**Galway City Community Network,
The Public Participation Network in Galway City**

**Galway City Council Proposed BusConnects
Cross-City Link**

GCCN Submission

Re: An Bord Pleanála 314597: University Road to Dublin Road, Galway City.

TYPICAL SECTION A - A
UNIVERSITY ROAD
LOCATED ON GA SHEET 01
DRAWING REF: BCG-GA-00-01

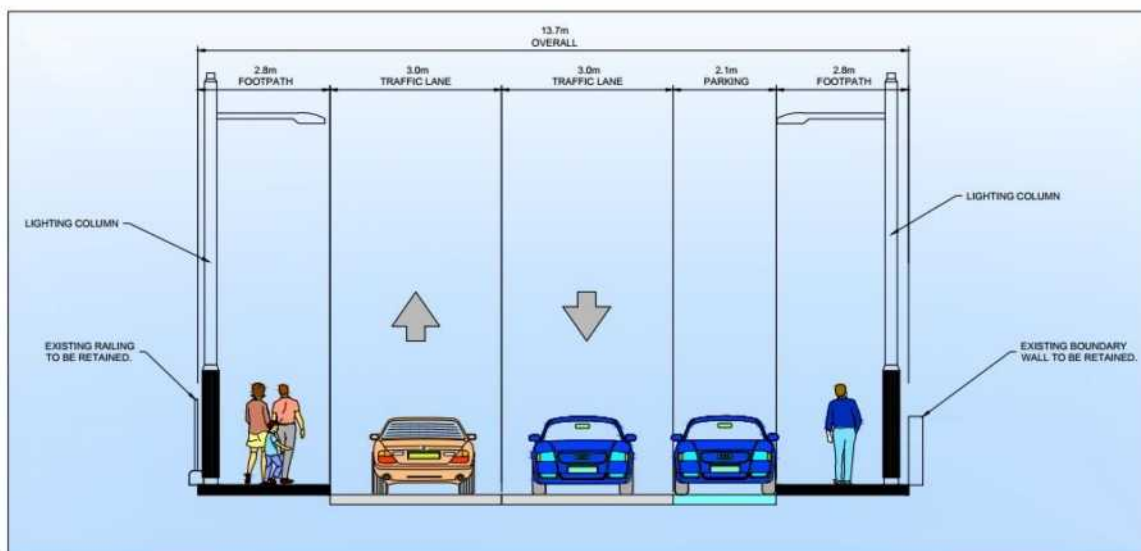
Discussion University Road: If the parking lanes are removed there is scope within the cross section for spacious 2.8m footpaths with wide 4.6m kerb lanes. There is also scope for 2m footpaths, 1.8m cycle facilities and 3m wide general traffic lanes.

There are two sections of on-street parking. The section on the northwest of University road runs along a series of properties that have front gardens - in some cases already converted to driveways. This suggests that other properties at this location could implement driveways and off-road parking, removing the need for on-street parking. On the southeast of University Road there is a section of on-street parking opposite the Millennium Park. If the park is under council ownership then the parking could be relocated to a strip that takes in part of the current park lands.

TYPICAL SECTION C - C
SAINT FRANCIS STREET

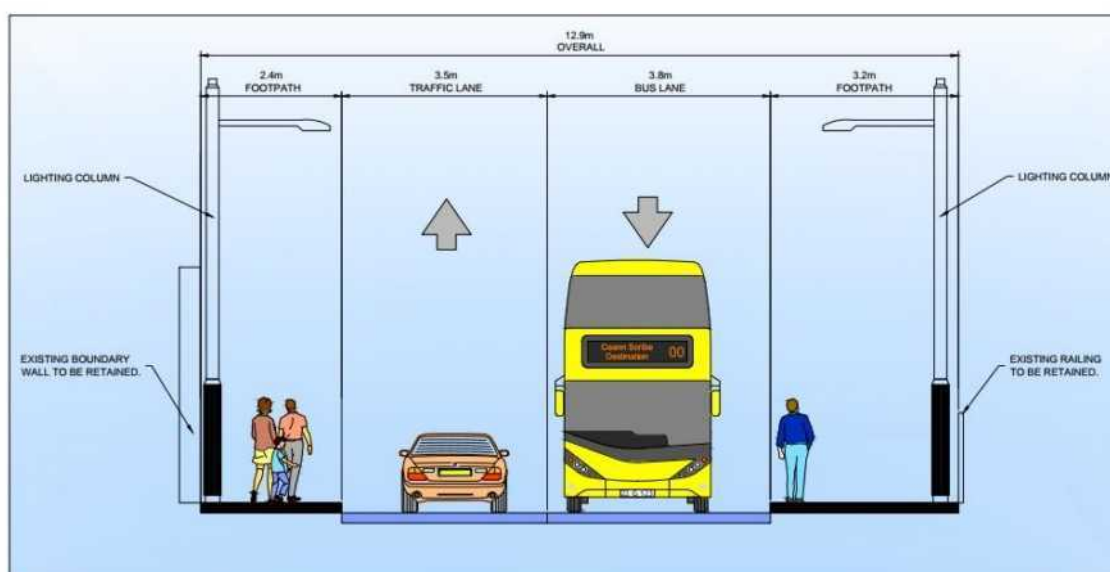
Discussion St: Francis St: The drawings provided in Appendix B2 show that under this scheme Newtownsmith is to be converted to one-way operation going north thus removing it as a means for bicycle users to access Eglington St. This suggests that Francis St will now be the default way for people on bikes to access Eglington St/Shop St. The dimensions published indicate that there is room for 2m footpaths with wider 4.4m kerb lanes.

TYPICAL SECTION E - E
ELINGTON STREET
LOCATED ON GA SHEET 04
DRAWING REF: BCG-GA-00-04

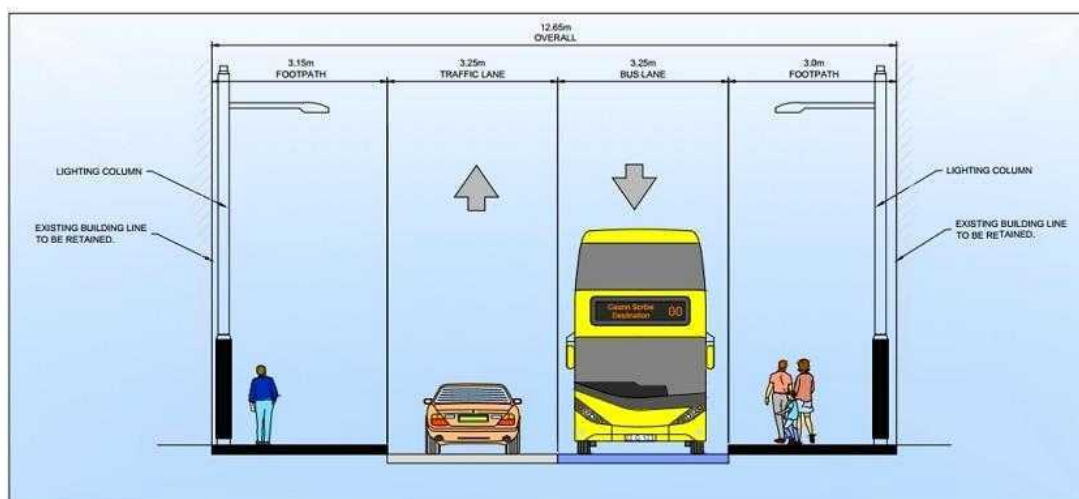
Discussion: Eglington St There is scope within the existing cross section to provide wider kerb lanes 4.3m and 2m footpaths.

TYPICAL SECTION F - F
BOTHAR BHRÉANDAIN UI EITHIR
LOCATED ON GA SHEET 05
DRAWING REF: BCG-GA-00-06

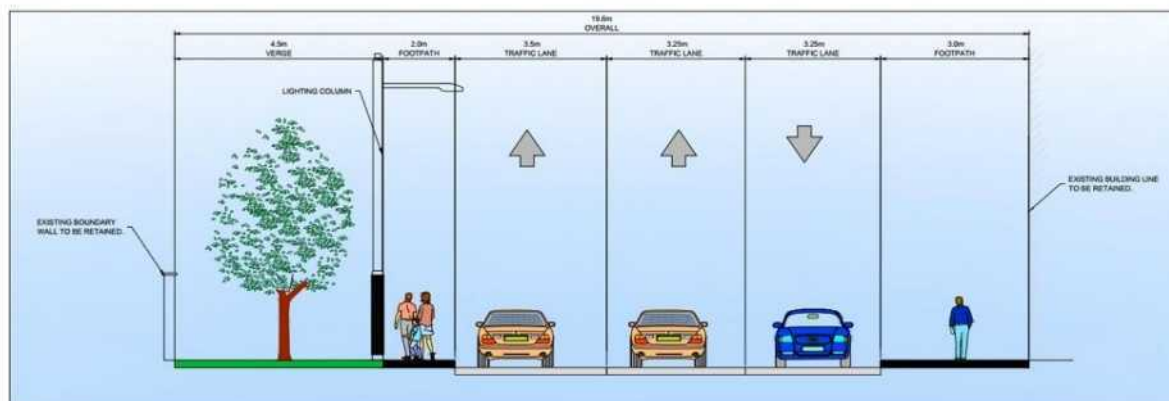
Discussion: Bothar Bhreandain Ui Eithir: By using the 4.5m verge shown in the cross section it is possible to provide 2m cycle facilities on either side of the road.

Location: Forster St.

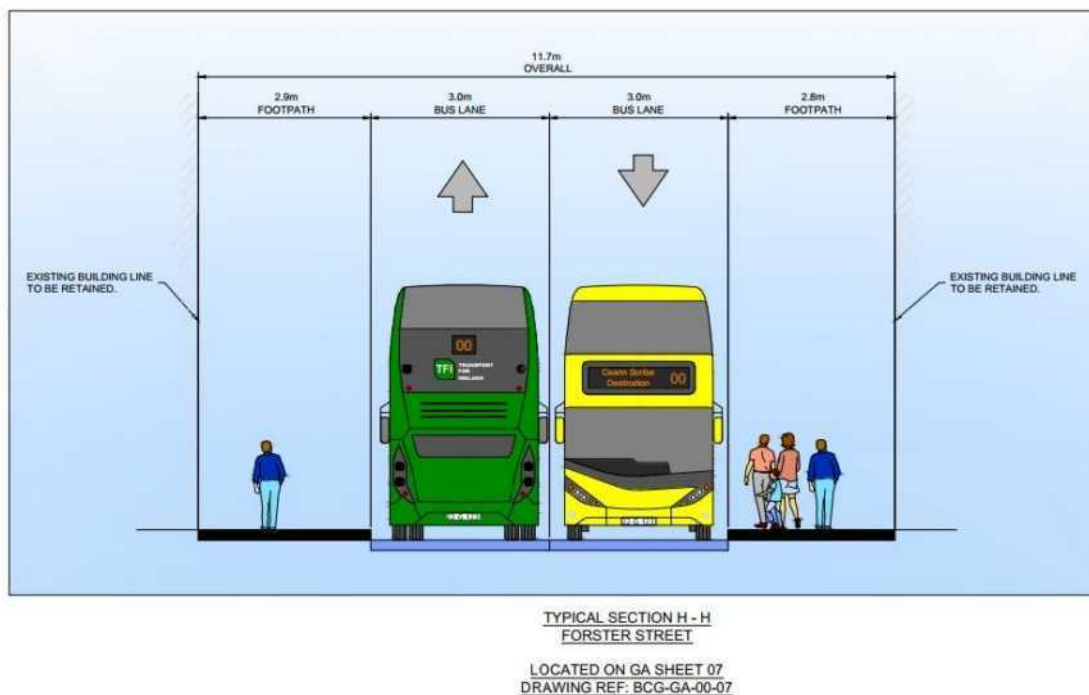
Discussion: Forster St. In the applicant's drawings Forster street is shown as having bus lanes with no apparent provision for cycling. Alternative 1: By using 2m footpaths it is possible to provide wider bus lanes of 3.8m. 3.8m bus lanes are below the necessary width given by some sources. The problems associated with this lane width might be mitigated by omitting a central lane marking and providing some kind of edge marking (hard shoulder marking etc) Alternative 2: This would involve providing wider footpaths and 2m advisory cycle lanes with a single central traffic lane of 3.7m. In this arrangement motor traffic uses the central lane but oncoming vehicles must merge into the cycle lanes to pass each other. This is a type of treatment (sometimes termed "Edge lane roads") that is established in the Netherlands, Germany and Denmark and has seen some use in the UK.

Location: College Road (Sportsground)

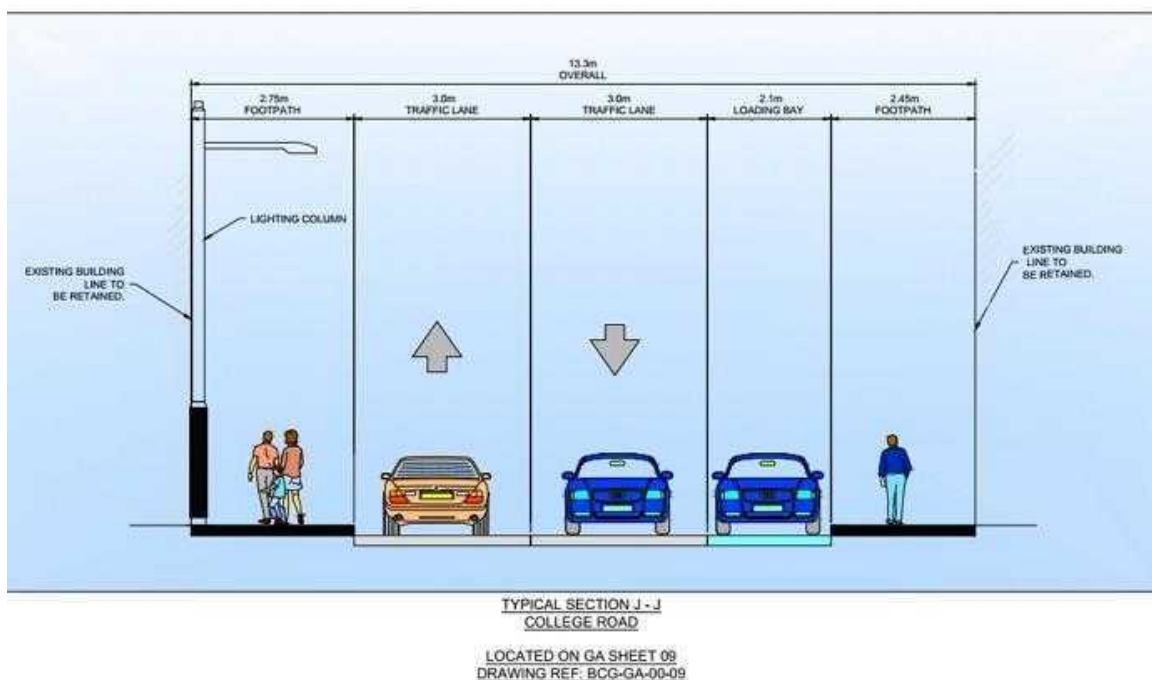
Discussion: College road (Sportsground) The current plans suggest bicycle users sharing with motor traffic in narrow substandard lanes of 3m. Alternative 1: Remove or relocate on street car parking to provide 2m footpaths and 4.6m wide traffic lanes. Alternative 2: Remove or relocate on-street parking and provide 2m footpaths and cycle lanes of 1.6m and 3m general traffic lanes. Some sources would view 1.6m cycle lanes as being unacceptably narrow and to be avoided. This author shares that view. However 1.5m cycle lanes are found at other locations in the city. Some of the

properties at College road already have ample car parking on site. It is also clear that there are lands north of the road that are already used for parking. Also Galway City Council is in the process of vacating the current site at City Hall for another location. Some of the City Hall lands could be incorporated into the scheme to provide for relocated car parking. There are disabled parking spaces on-street at college road and if there is no suitable alternative location then they could be retained. This would interrupt any cycle lanes so coherent and clear markings would be needed to advise drivers to expect people on bicycles at the obstruction.

Extract from drawing Appendix B2 General Arrangements BCG-GA-02 showing new one-way street restrictions circled in red. The orange arrow shows the imposed direction of travel for people on bicycles who try to use the new bridge.

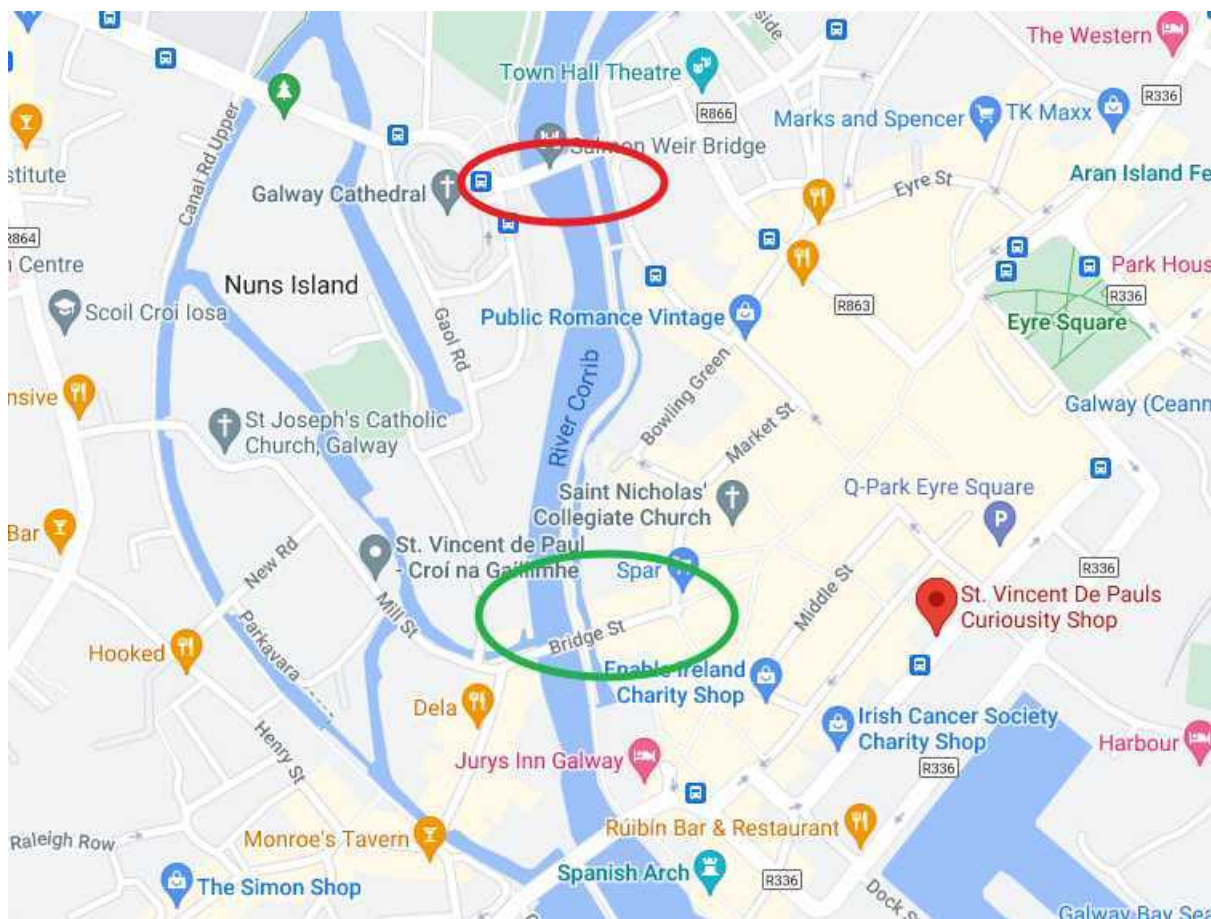
point to streets that would bring cyclists to the new bridge is via Bridge St and Lombard/Market Streets on the west side of the mediaeval quarter of the city.

Merchants Road

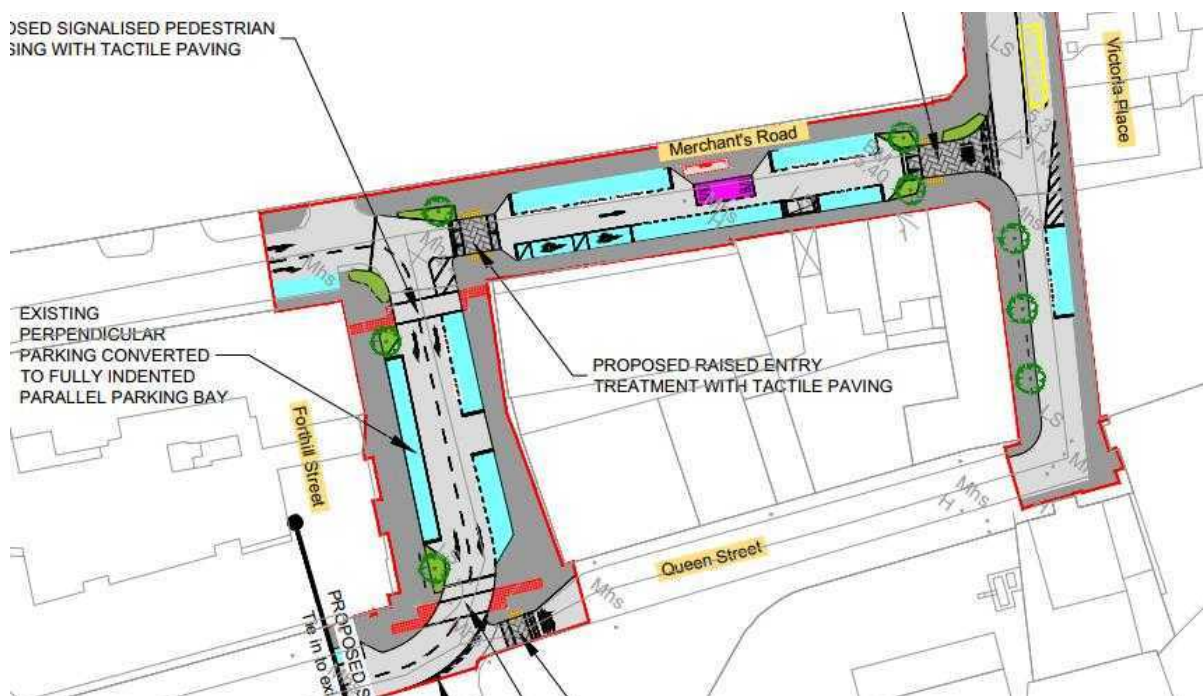
The drawings show Merchants road retained as a one-way street with no provision for contra-flow cycling. This confirms that under the Bus Connects proposals the unsuitable Dock road remains one of only two routes for people on bicycles to access the core of the city from the east. If contra flow arrangements were provided along Merchants road between Abbeygate St and Victoria Place this could be the beginning of an alternative circulation route for bicycle traffic into and through the old core of the city.
